Subject: Viton Accelerator Pumps - Current and Past Models Equipped with Dual and Quadrajets

Model and Year: 1975 - 1983 Chevrolet Vehicles Equipped with Dual and Quadrajets

Bulletin No: 83-I-65

FIGURE 1. (DUALJET SHOWN)

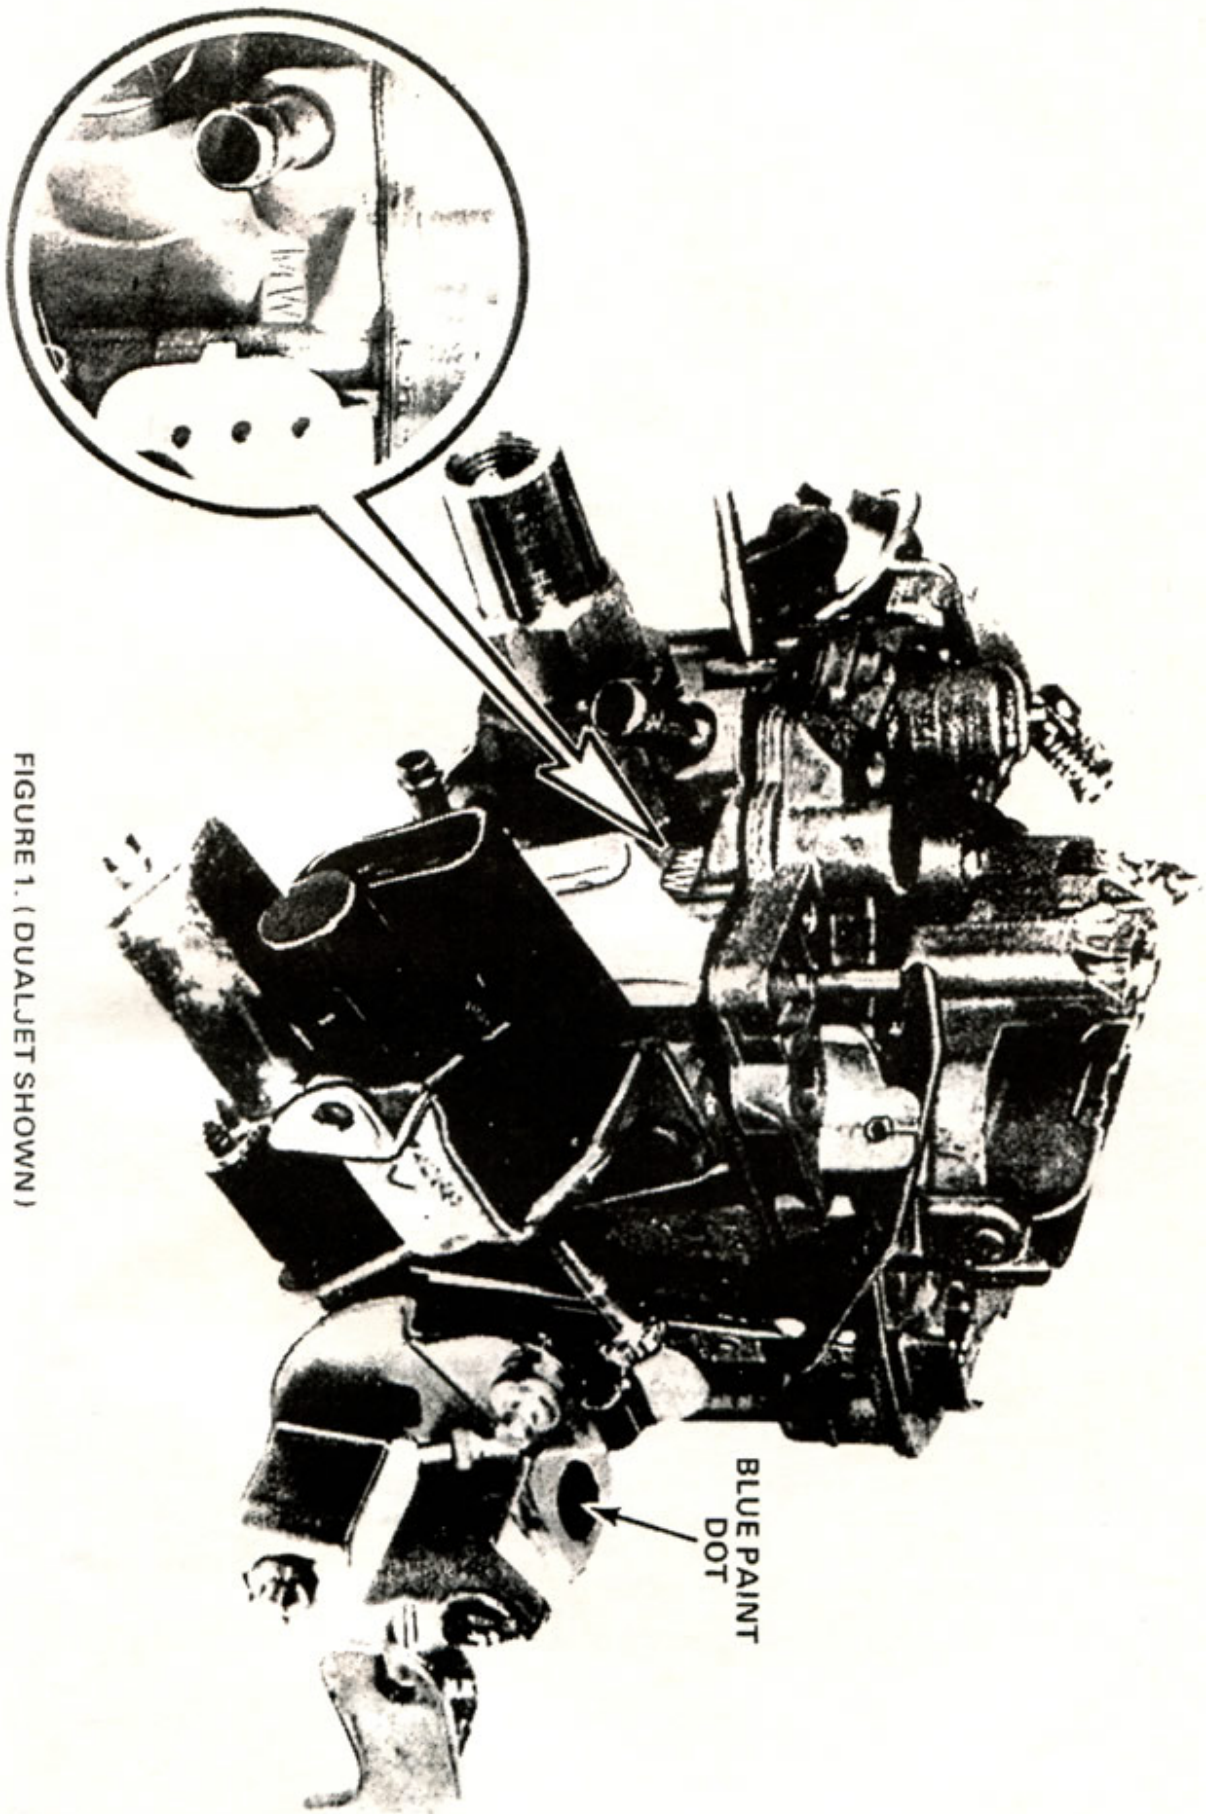
Float bowl assemblies that have the letters "MW" (machined well) embossed next to the throttle position sensor electrical connector use the red lip (with garter spring) viton accelerator pump only . See Figure 1.

Some 1982-83 "MW" flat bowl assemblies used during production were assembled with the red viton pump and some were not. if the float bowl

assembly does not contain the red viton pump, a blue dot will be on the rear of the throttle body near the bolt hole. See Figure 1.

PUMP ASSEMBLIES USED IN DUALJET AND QUADRAJET

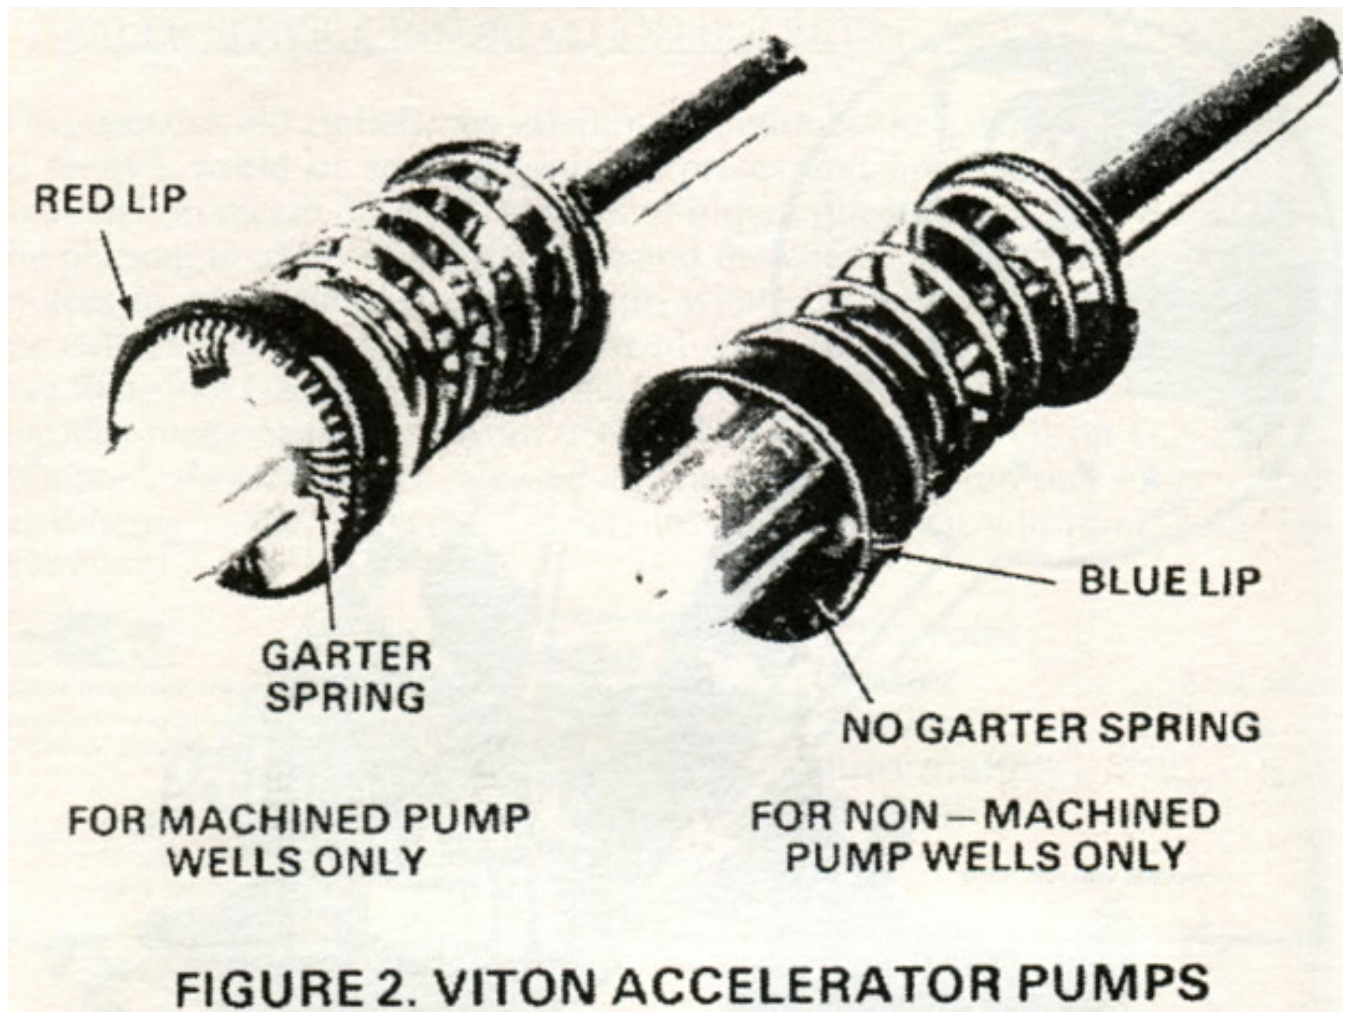
Viton service replacement pumps are identified as H.D. (Heavy Duty) in the parts book and are shown in Figure 2.

Red lip (with garter spring) -- Machined well only (MW)

Blue, thin lip -- Non-machined well only

Red lip (with garter spring) -- 17072978
